PLANNING REPORT

Planning and Zoning Commission

Germain Honda Dublin Expansion 26-008 INF

Proposed layout: demolished buildings in red hatch, new buildings as shown. Rite Rug site in brown and blue, left side.

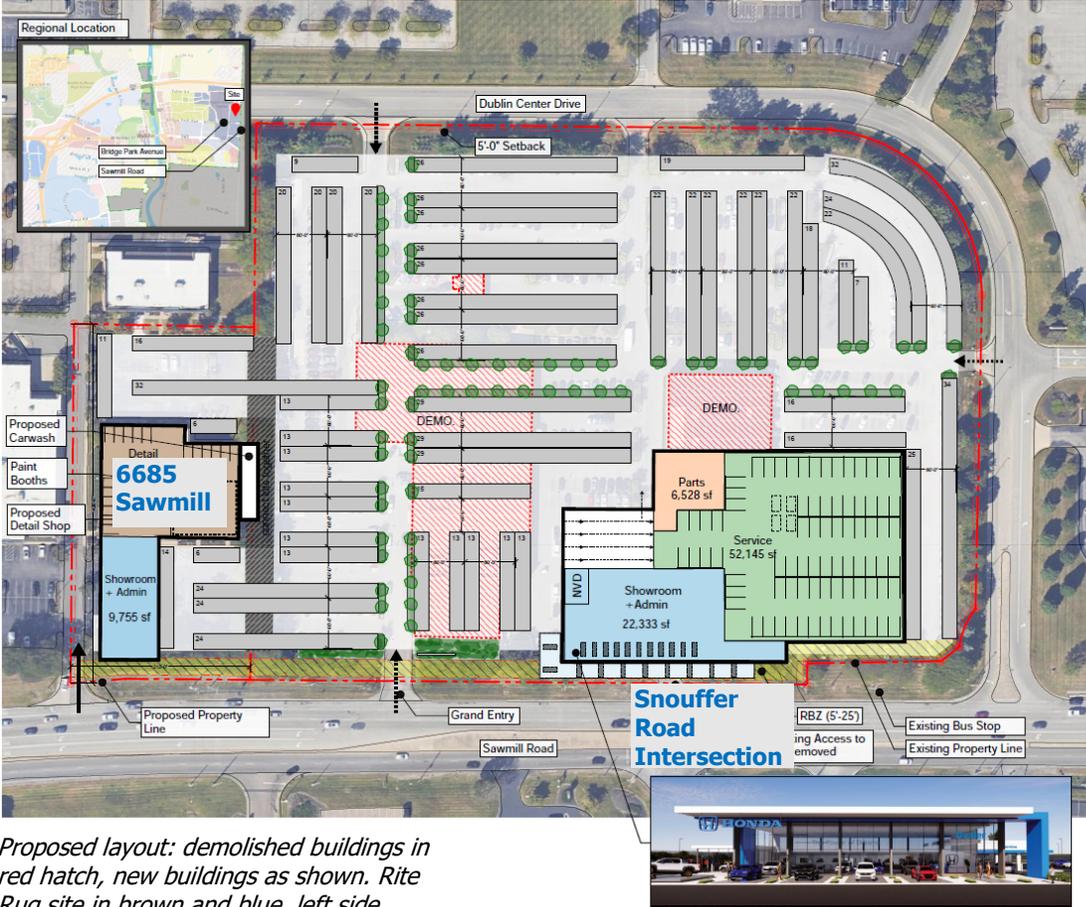
The street network is an essential means to achieve the BSD vision. The applicant is not currently showing any of the required future Neighborhood Streets that create the necessary fine-grained scale of the neighborhood and streetscape, nor the future Dublin Center Drive and John Shields Parkway intersection or the extension of a street at the signalized Sawmill Road and Snouffer Road intersection. The main access point to the campus is shown on Sawmill Road ("grand entry" on drawings), a PFS that generally restricts driveways and would require City Engineer approval. The anticipated Snouffer Road signalized intersection, the best location for a Sawmill Road connection, is prevented from completion by the currently proposed building location in the northeast corner of the site. Completion of this intersection will accommodate northbound left-turn movements and pedestrian crossings with crosswalks and signals, including across Sawmill Road, making this a high-priority location. This access point would not be a full movement intersection, because a center median would restrict east-west movements. The "grand entry" would not have full movements either for the same reason, and the northbound left would not be allowed.

The new buildings appear to achieve the Code-required 45% Front Property Line Coverage for a Commercial Center, per §153.062(O)(7), when the site is considered as a whole. The location of the main building, however, prevents the completion of the Snouffer Road signalized intersection as previously noted. Staff has asked the applicant whether the proposed functions can be split into smaller, individual buildings that better support the BSD Street Network. The applicant's representative stated that this arrangement is not ideal but has been done on sites where the service location is remote. The proposed buildings also do not create the anticipated Shopping Corridor on Dublin Center Drive.

The corner of John Shields Parkway and Sawmill Road is highly visible and marks the first entry into Bridge Park, though it is restricted to right-in/right-out movements. Staff is concerned that the service portion of the building is shown at this pivotal location, which is identified as a potential Gateway in the SCN map. At a minimum, the showroom/administration building should be on this corner, with the service area hidden more toward the rear of the site or architecturally disguised farther south on Sawmill Road. A gateway feature/open space should be incorporated, with an opportunity to further enhance the existing COTA bus stop at this corner. Dublin, via Capital Improvement Plan funding, is making enhancements at this bus stop, including a shelter, bike racks, trash/recycle receptacles, and sidewalk connections along Sawmill Road. This concept was discussed with the applicant.

While very early in the development process, the proposed site plan does not include pedestrian facilities, and the overall layout is not conducive to pedestrian movement. This topic has been discussed during previous applications, with those improvements committed to later phases. Staff recommends that, with this redevelopment proposal and the necessary Conditional Use, greater progress needs to be made on this goal.

Other considerations include ensuring that car haulers are unloaded on-site, not on public rights-of-way. It is unclear where this might occur; however, the applicant understands this requirement. Both bike and EV parking are required, in accordance with the Code and recently adopted plans. The proposed car wash on the south side has an opening that faces Sawmill; how that would be screened is not yet clear.
